SUBJECT: INCORRECT TIRE LOADING INFORMATION ON VIN DECAL

Safety Recall Notice 06V-059

Reference Victory Safety Recall Bulletin V-06-01

Example of U.S. Consumer Letter

Apply decal over the GAWR portion of the VIN decal on the motorcycle.

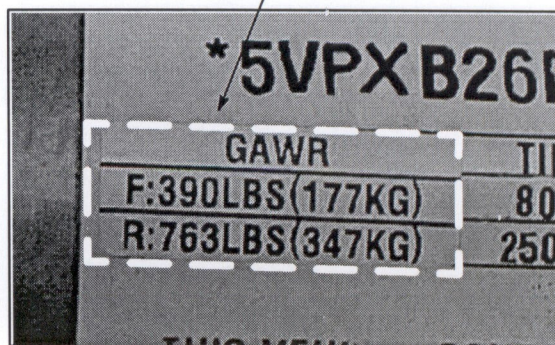
On the affected motorcycles, the Vehicle Identification Number (VIN) decal located on the left front downtube of the motorcycle frame incorrectly lists the GAWR (Gross Axle Weight Rating) for the front axle as 405 pounds. The correct GAWR for the front axle is 390 pounds. Reliance on the incorrect data may lead to overloading of the front tire which can result in a sudden loss of vehicle control and possibly a crash.

Incorrect: F: 405 LBS (184KG)
R: 750 LBS (340KG)

1. Clean the decal on the motorcycle with warm soapy water to remove all oil, grease or dirt.
2. Rinse with clear water.
3. Dry decal and surrounding area thoroughly.
4. Carefully remove a new GAWR decal at right and apply it over the GAWR area of the decal on the motorcycle as shown. Be sure all previous GAWR information is covered, and press decal firmly in place.

Correct: F: 390 LBS (177KG)
R: 763 LBS (347KG)
